**NOTICE OF MEETING
PLANNING & ZONING COMMISSION
TUESDAY, MAY 5, 2026
T.W. "TURK" CANNADY – CEDAR HILL ROOM
CEDAR HILL GOVERNMENT CENTER
285 UPTOWN BLVD. – BLDG. 100
CEDAR HILL, TEXAS 75104
6:00 P.M.**

RE: Case No. FP-781-2026 (Final Plat – Milotte Margaret Estates, Lots 2R, 3R-1, and 3R-2, Block 1)

SEE SHEET 7

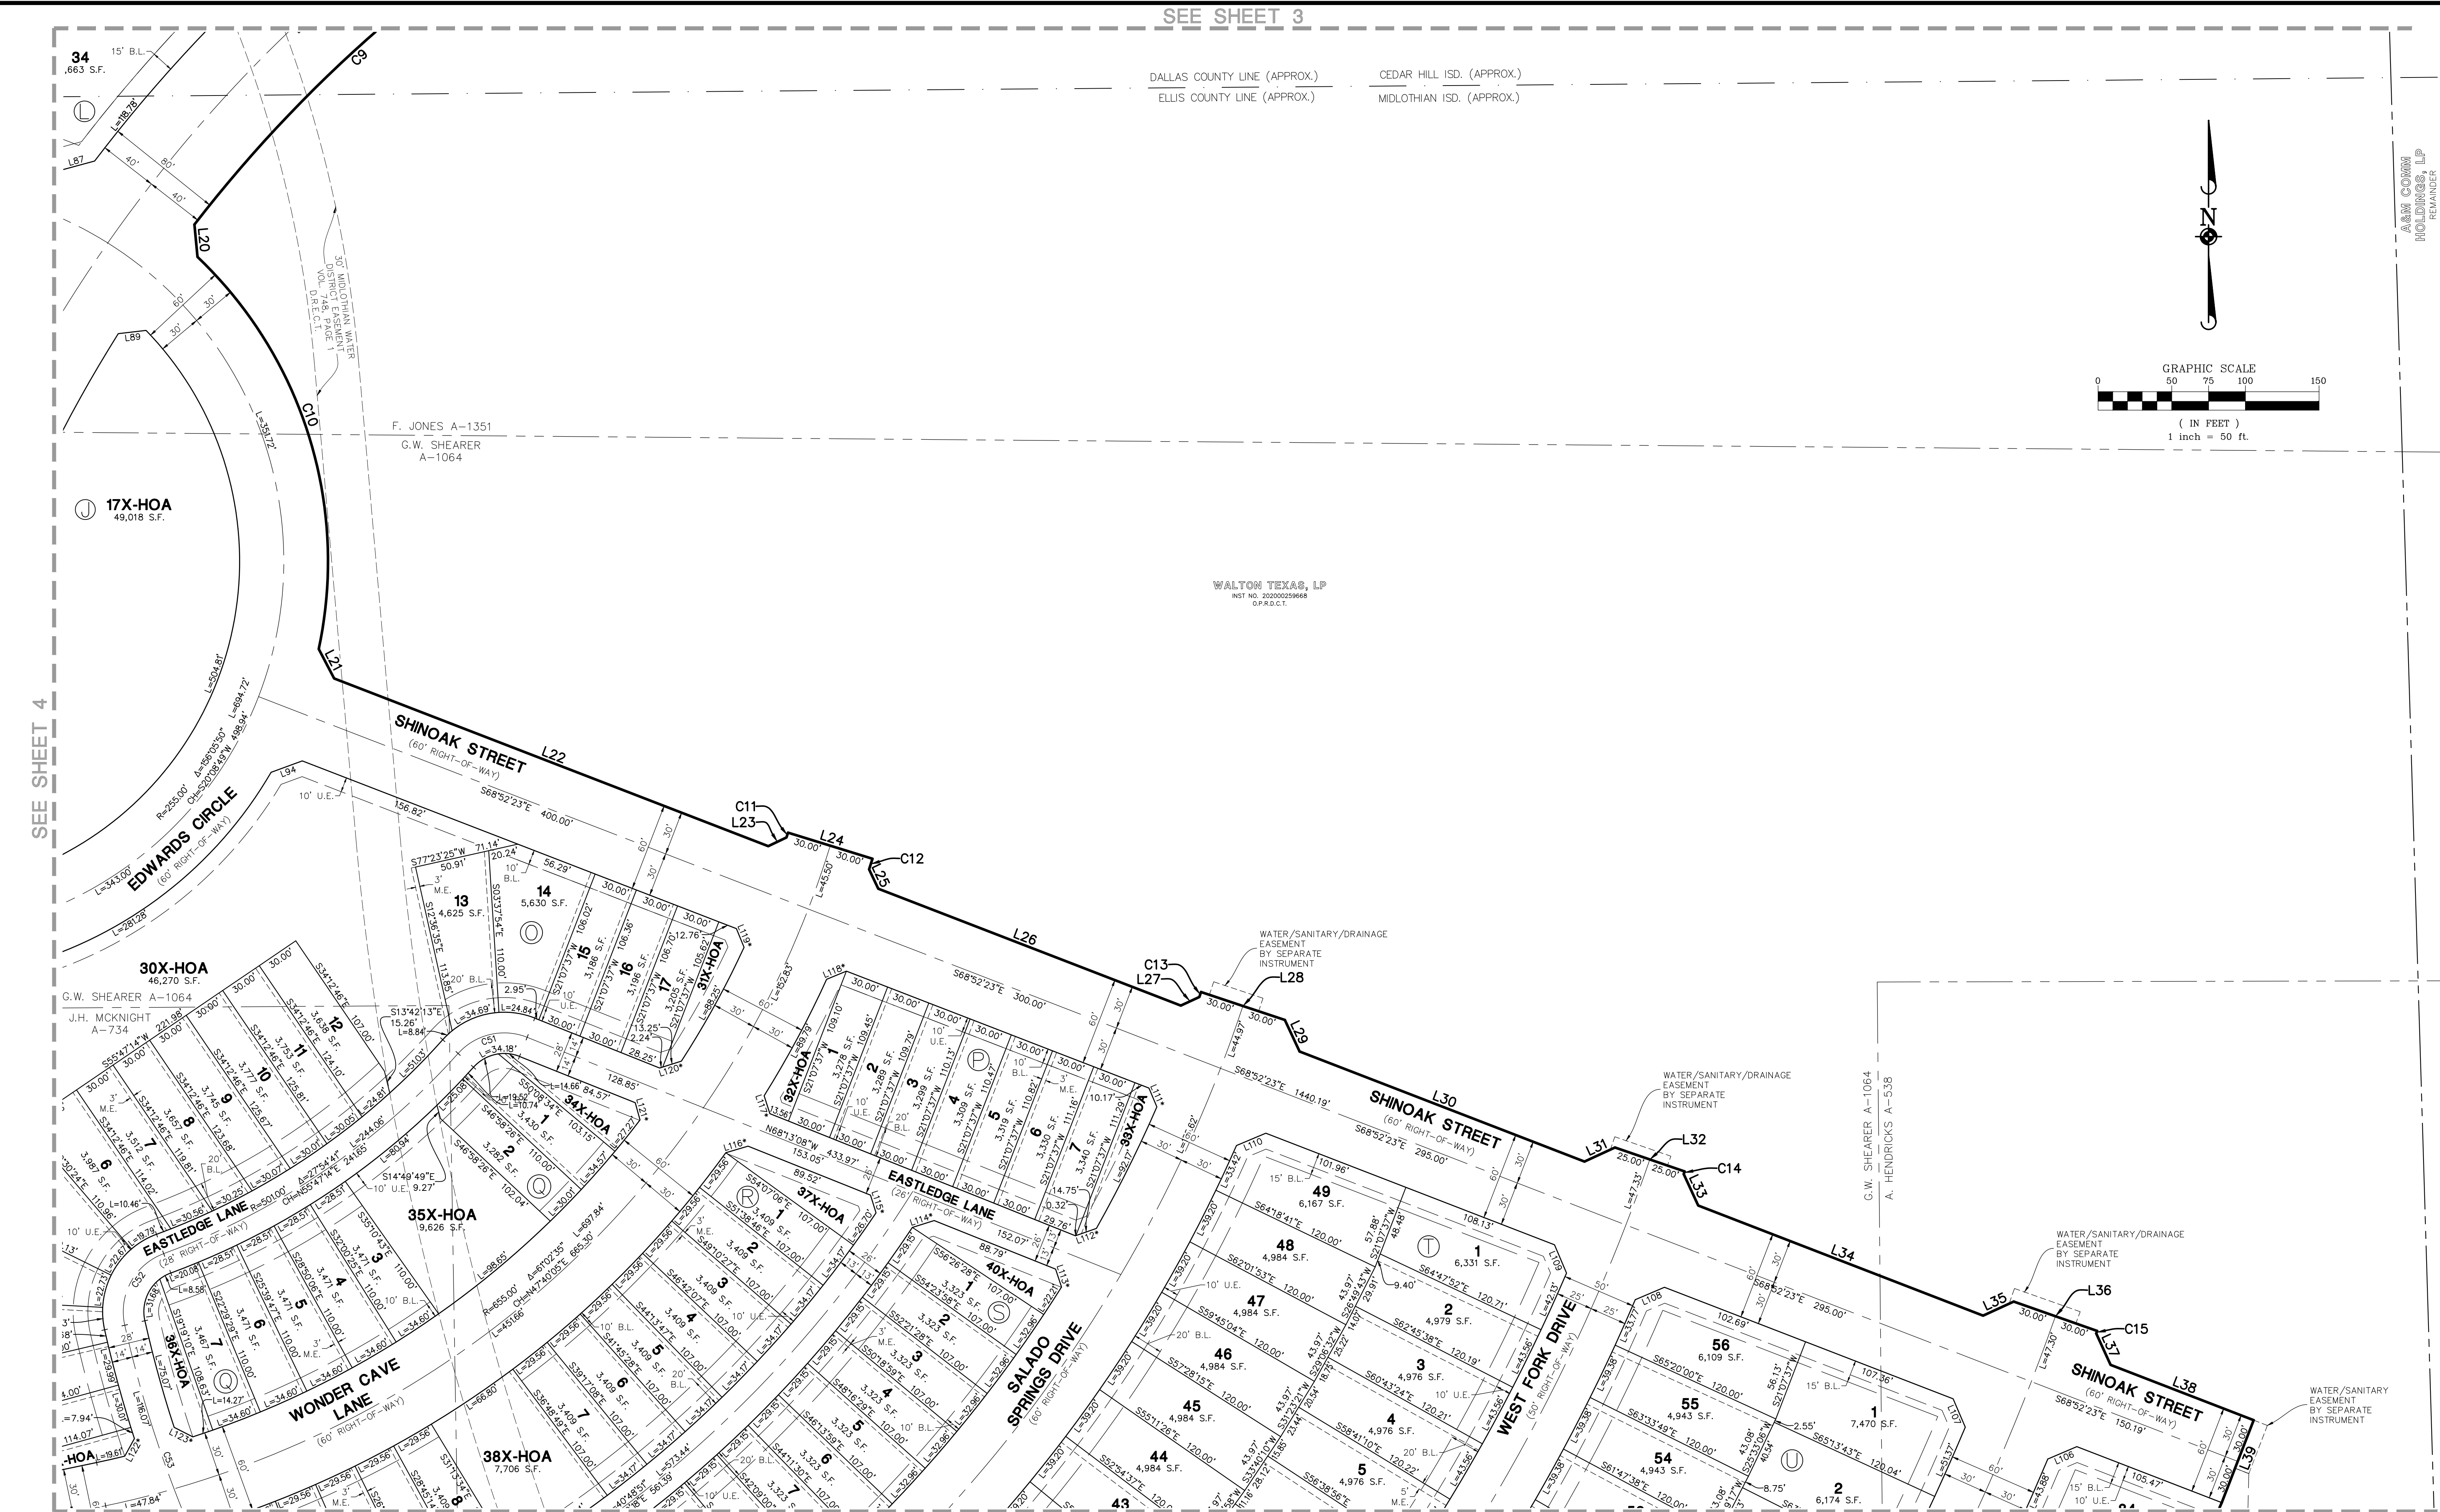
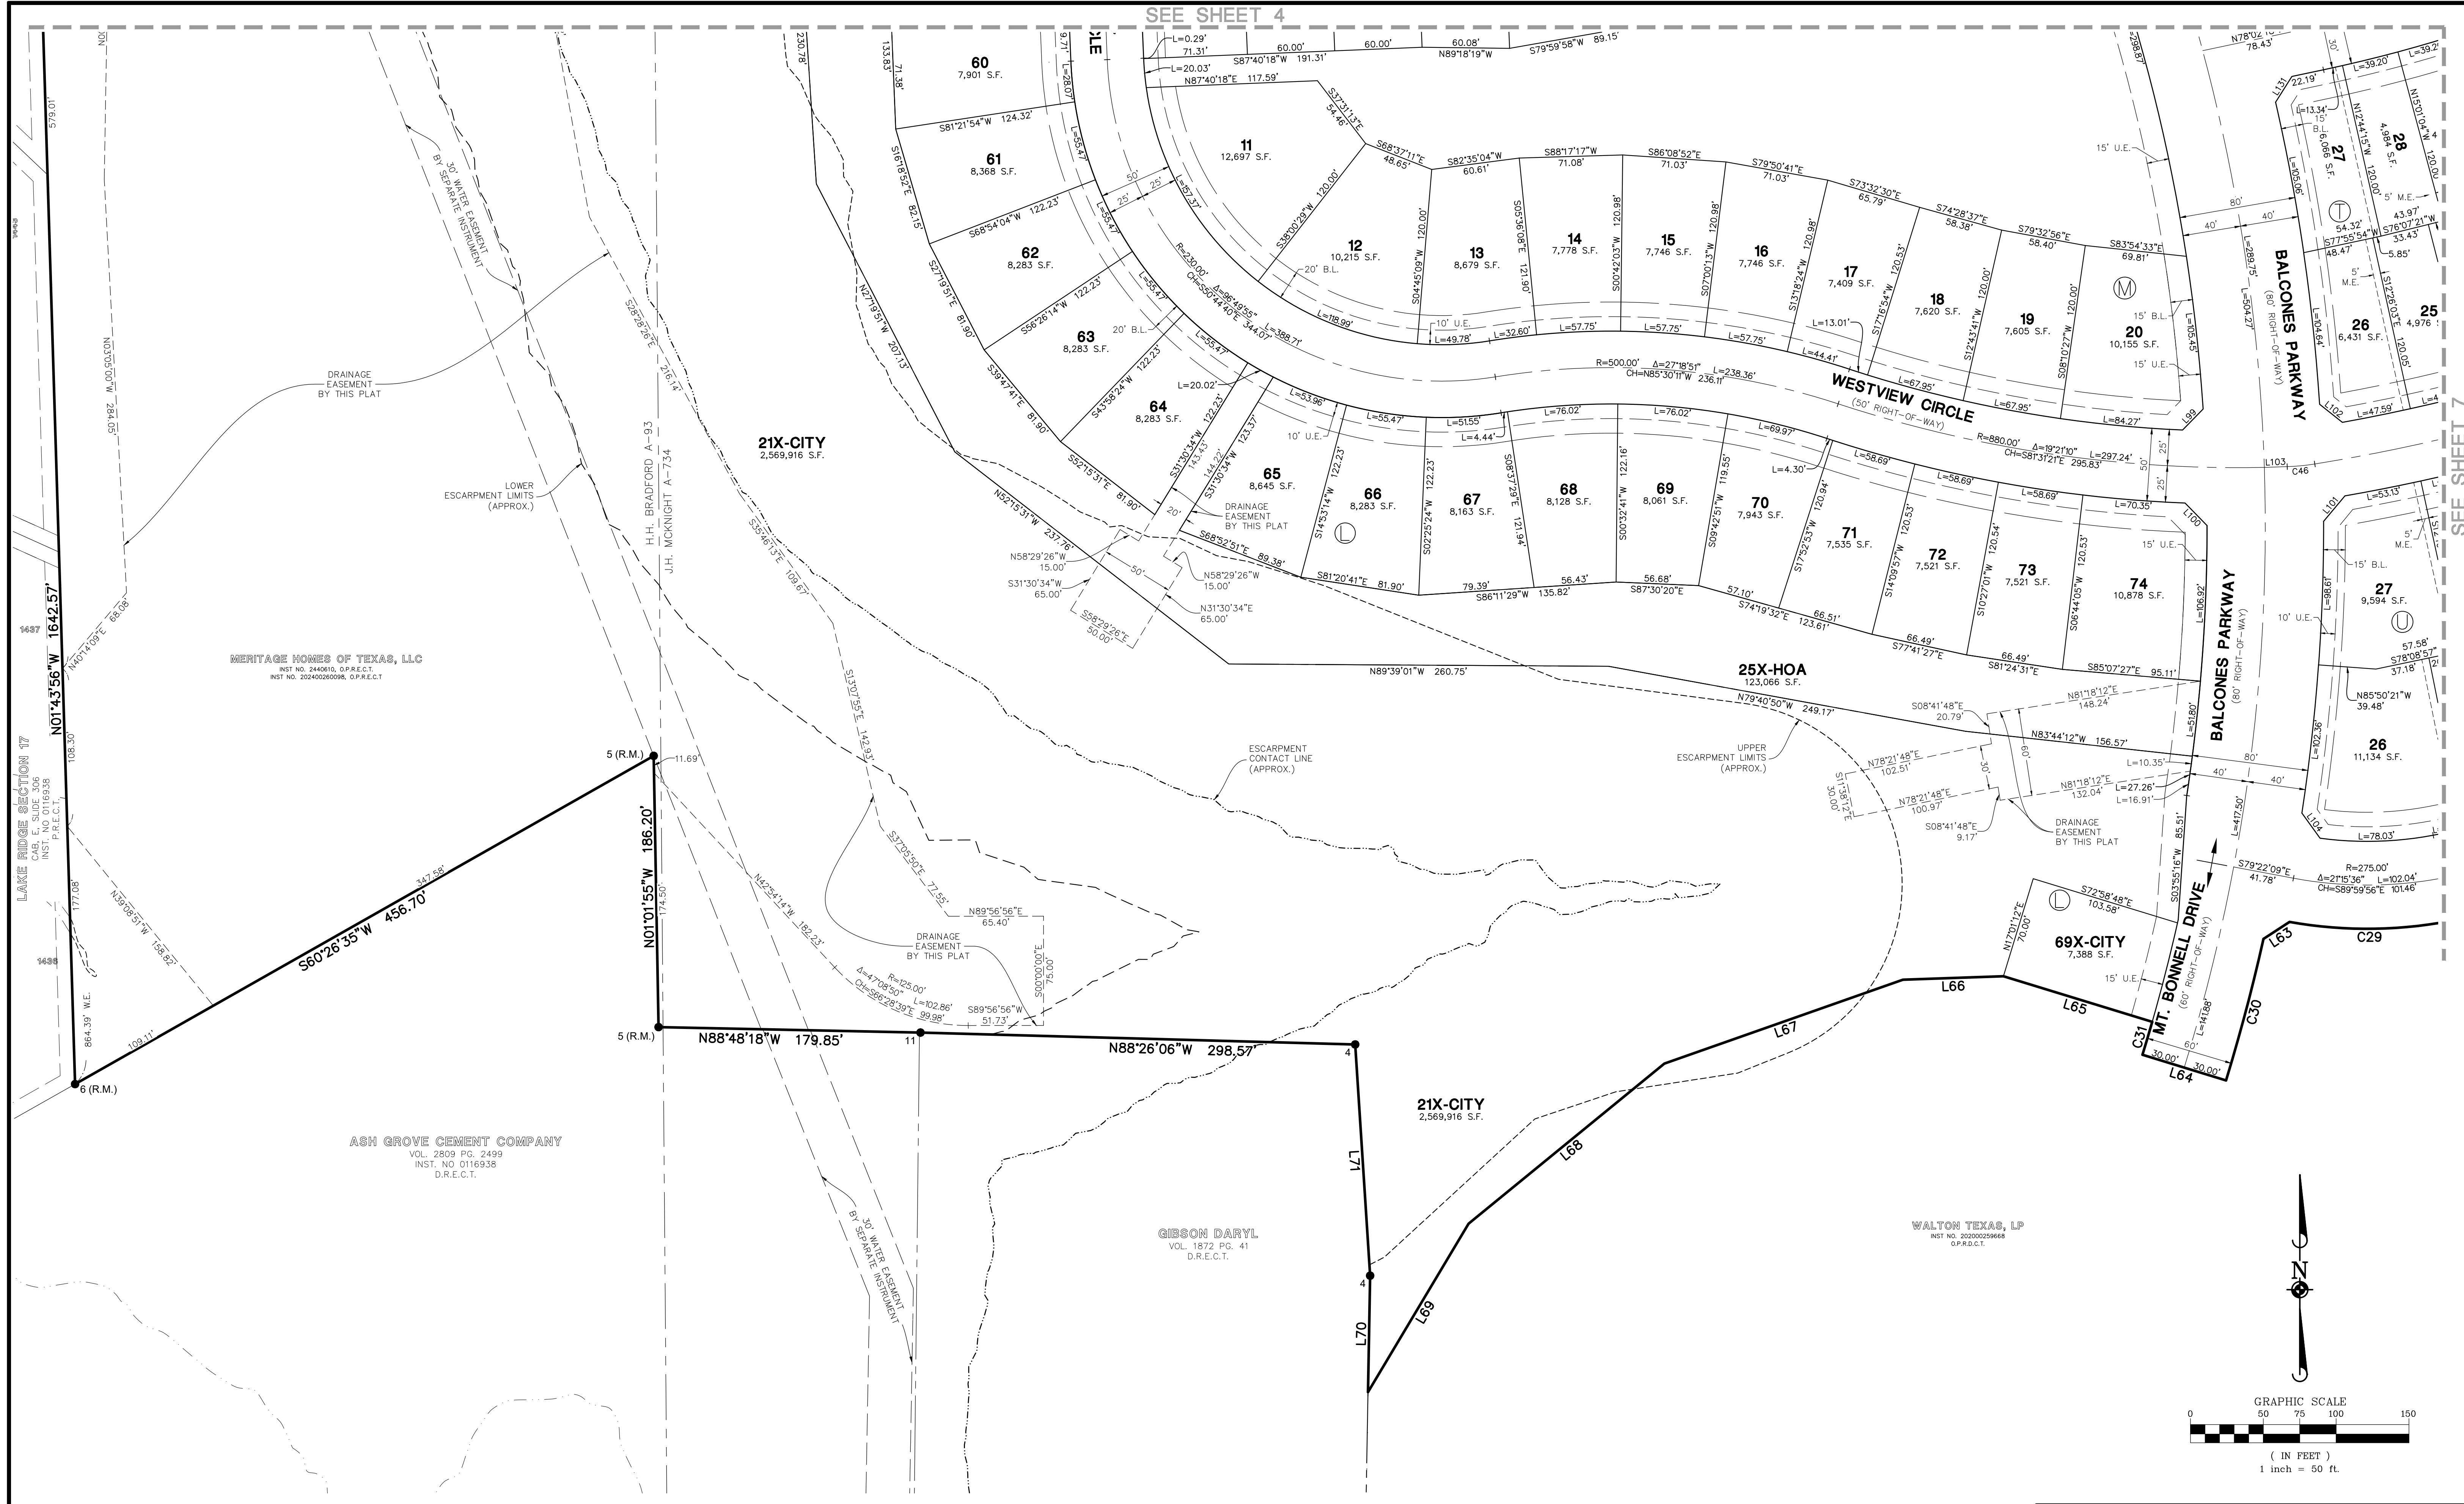
Planning Department	Code Citation
<p>1. Provide evidence of plat distribution to the applicable franchise utility companies.</p> <p>Simply send them an email to the applicable contacts, and copy the City and with the following: <i>"On behalf of the (applicant's name), we are submitting a final plat at (address) for a residential subdivision of 238 lots in Cedar Hill, Texas. If you have any questions, please contact me and/or the applicant."</i></p>	<p>Chapter 20, Section 20-11(c)(1) thru (9) of the Subdivision Regulations</p>
<p>2. Provide approval from the Post Office regarding the proposed residential subdivision layout PRIOR TO RECORDATION of the Final Plat.</p>	<p>Chapter 20, Section 20-11(c)(9) of the Subdivision Regulations</p>
<p>3. Provide a certified copy of the owner association agreement and association by-laws where required for maintenance prior to the recordation of the plat.</p>	<p>Chapter 20, Section 20-11(b)(21)(b) of the Subdivision Regulations</p>

<p>4. Add case no. FP-782-2026 underneath the Title Block.</p>	
<p>5. This property is within both Dallas County and Ellis County. Staff contacted both Counties requesting requirements for the recording of this Plat.</p> <ul style="list-style-type: none"> • Ellis County response – plat must meet both Texas Property Code for recording and TLGC. Plat sheet size must be 18"x24". • Dallas County response – plat must clearly show/delineate both Counties. Typical Plat sheet size is 24"x36", but they will accept 18"x24". <p>Contact each county directly to confirm and revise sheet layout as needed.</p>	<p>See the attached County correspondences</p>
<p>6. Provide the following note on the plat. "Selling a portion of this addition by metes and bounds is a violation of the Subdivision Regulations and State law and is subject to the withholding of utilities and building permits."</p>	<p>Chapter 20, Section 20-2 of the Subdivision Regulations and TLGC, Section</p>

212.004
7. Remove all building lines and/or yard setback lines and call outs from the proposed plat. Add the following note on the plat. "Building setbacks shall comply with the Zoning Ordinance at the time of the Building Permit."	Chapter 20, Section 20-11(b)(9) of the Subdivision Ordinance

8. Provide the bearing and distance information for all proposed easements.	Chapter 20, Section 20-11(5) of the Subdivision Ordinance
9. Label all existing and proposed easements.	Chapter 20, Section 20-11(b)(5)c of the Subdivision Ordinance

10.The table listing the residential lots and the HOA/Open Space lots has missing lot numbers. Please revise.	Chapter 20, Section 20-10.b(8) of the Subdivision Ordinance

11.Provide the recording information for all proposed off-site easements and/ or easements not by this plat, on this plat prior to the recordation of the plat.

12. Revise the Title Block to separate how many acres are in Dallas County and Ellis County. Add "Addition" to the Title Block and under "Dedication".	Chapter 20, Section 20-11(b)(11) of the Subdivision Regulations; Chapter 20, Section 20-11(f) of the Subdivision Ordinance

13.Per PD, A minimum of 10% of the total 30' / 40' / 50'/ 60 -ft lots with the property may be allowed no more than 5% reduction in area due to site constraints. Verify and confirm.	PD No. 2024-813 Section 10

14. Provide an exhibit that overlays the following information on a plat layout to confirm the maintenance easement locations on this plat: a. all the retaining walls required per engineering plans b. all the fences/screening walls required that will be owned and maintained by the HOA per Section 10.O of PD-2024-813. c. all the maintenance easements associated with walls and fences listed above.	Chapter 20, Section 20-11(b)(19)

15. Remove the telephone and email address from plat.	
16. Add "By this plat" to all proposed plats and add "Dedicated by this plat" to all city properties.	
17. Label all HOA lots on all sheets	
18. Confirm that the meets and bounds does not have to be separated per county property.	
19. Add the Title within the Meritage Homes of Texas Organization for Frank Su under the Dedication Certificate.

Parks Department	Code Citation
1. Park Land Dedication per PD Ordinance has been satisfied. The park development fee of \$700 per dwelling unit will be required. The developer is constructing a 10-foot concrete city trail that is approximately 3,300 linear feet with Phase 1 infrastructure improvements. The developer may utilize this fee requirement for the construction of this trail. Please provide a cost estimate (OPC) for the construction of this trail.	Chapter 20, Section 20-42(c) & Section 20-43(a) of the Subdivision Regulations
2. Provide 10-ft Trail Easements for the trail sections that cross HOA lots.

Public Works Department	Code Citation
1. Provide Northern and Easterlings for at least two corner pins for reference in city GIS system.	Chapter 20, Section 20-11(b)(3) of the Subdivision Regulations
2. Please remove the escarpment limits and contact line from the Plat. However, a note shall be added that the escarpment exists and that there is a plan associated. This shall comply with the City Ordinance and the escarpment plan.	Chapter 20, Section 20-75(c) of the Subdivision Regulations
3. Please indicate that City lots are being dedicated by this Plat.	
4. Please add a note stating any changes in the approved grading plans shall be submitted to the city.
